a Mixed Use Neighborhood

GENERAL DEVELOPMENT PLAN

**SECOND AMENDMENT TO
GENERAL DEVELOPMENT
PLAN METROTECH PLAT**

The attached plans and text represent the second amendment to the General Development Plan for Metrotech Plat. The General Development Plan, prepared by Vandewalle & Associates and dated April 23, 2002, was recorded in the Office of the Register of Deeds for Dane County on May 14, 2002 as Document No. 3487367, as amended by an Alternation to an Approved & Recorded GDP, recorded February 3, 2003 as Document No. 3645406 ("GDP"). Metrotech is a mixed-use development located in the City of Madison, Wisconsin at 102 North Sprecher Road, more particularly described as ("Property"):

SITE PLAN

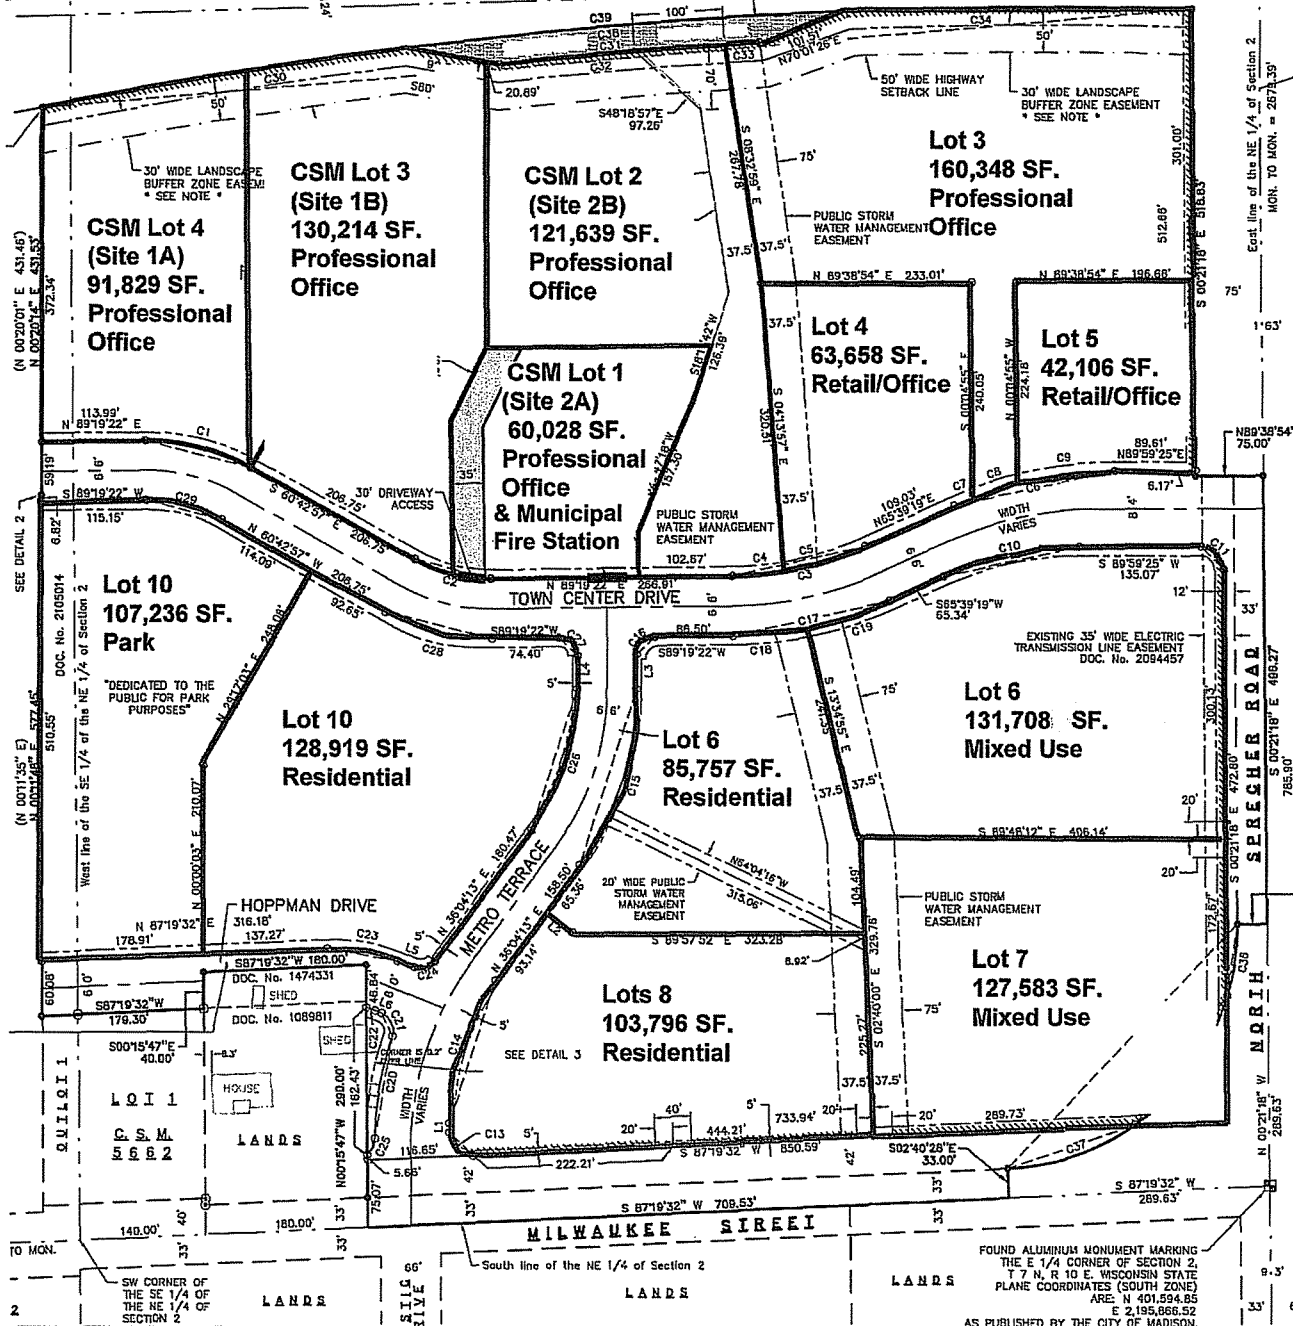
4. The General Development Plan maps appearing at ~~pages~~page 7 (recorded page 00418) and page 44 (recorded page 000455) of the GDP are hereby replaced with the ~~map~~maps attached hereto at Exhibit A. ~~The Illustrative Plan attached to the Alternation to an Approved & Recorded GDP, recorded February 3, 2003 as Document No. 3645406, is hereby replaced with the Illustrative Plan attached hereto at Exhibit B.~~
